**BEFORE THE PUBLIC UTILITY COMMISSION
OF OREGON
LC 43**

In the Matter of
PORTLAND GENERAL ELECTRIC
2007 Integrated Resource Plan.

STAFF'S INITIAL COMMENTS AND
RECOMMENDATIONS

Figure 1

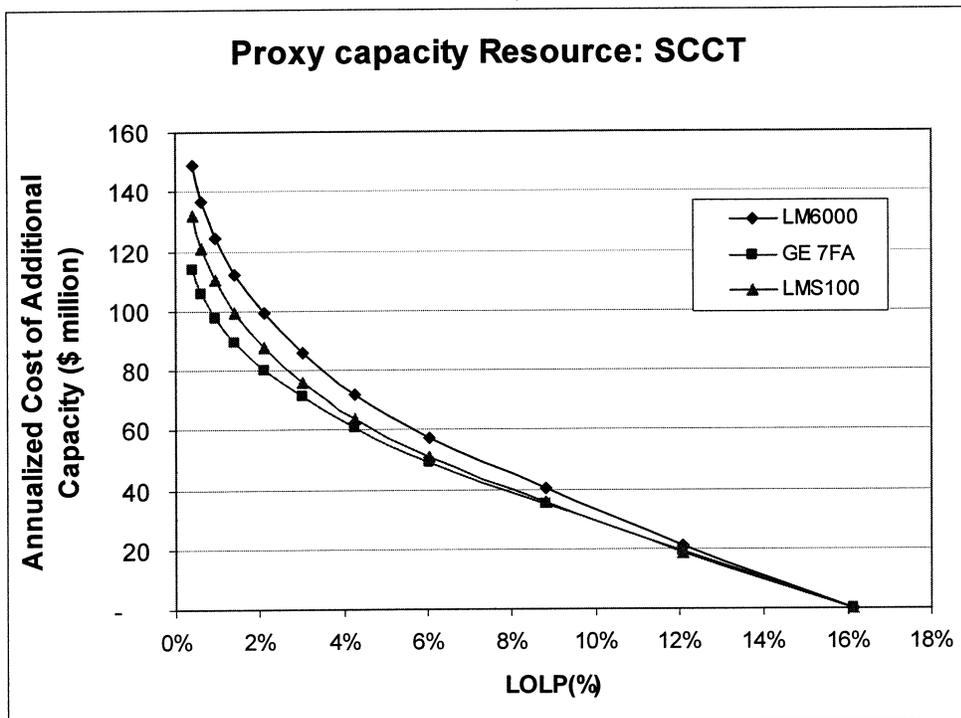
Regarding item c, above, the IRP did not include an assessment of costs associated with varying levels of reliability, even for PGE's preferred portfolio. However, in response to a request from Staff, the company provided a cost analysis for the preferred portfolio. *See* PGE's response to Staff Data Request No. 2. The analysis compares costs of the portfolio at various capacity reserve levels, based on the costs of three types of simple-cycle combustion turbines, and the corresponding LOLP.

The company finds the cost analysis supportive of its selected level of capacity reserves – a minimum of 500 MW in winter. This approximates a 12 percent planning reserve margin based on projected 2012 winter peak load. Further, 500 MW covers the company's largest generation shaft risks, the Port Westward and Boardman plants.

Figures 12-4 and 12-5 of the IRP consider capacity reserve levels and three corresponding risk metrics – loss of load probability (LOLP, expressed in % of hours in the year), expected unserved energy (expressed in annual MWa), and both 95th and 99th percentile measures of unserved demand (expressed in MW). Figure 1 below compares costs for various capacity reserve levels and the corresponding risk metric of LOLP. The costs are real (2006\$) annual costs (real levelized annual fixed costs, plus 2012 variable costs) required to meet given LOLP levels based on three types of simple-cycle combustion turbines – LM 6000, GE 7Fa, and LMS 100.

Figure 1 below exhibits the same characteristics as Figures 12-4 and 12-5 of the IRP. Large reliability improvements are achieved with initial reserve acquisitions, but a point is eventually reached in which additional investment in reserves yields comparatively small gains in reliability. Achieving an LOLP of less than approximately 2-3% becomes increasingly expensive, in terms

either of capacity resources needed (i.e. more than approximately 500-600 MW in Figures 12-4 and 12-5) or cost (i.e. more than the approximately \$80-90 million per year needed to achieve approximately 2-3% LOLP). For example, in Figure 12-4, there is an inflection point at approximately 500-600 MW and 2-3% LOLP. The first 500 MW of capacity reserve reduces LOLP from approximately 16% to approximately 3%, but the next 500 MW reduces LOLP by only approximately 3% (to close to zero). There are corresponding inflection points in Figure 1 below, at approximately \$80-90 million (the real levelized annual cost of approximately 500-600 MW of capacity resources) and 2-3% LOLP.
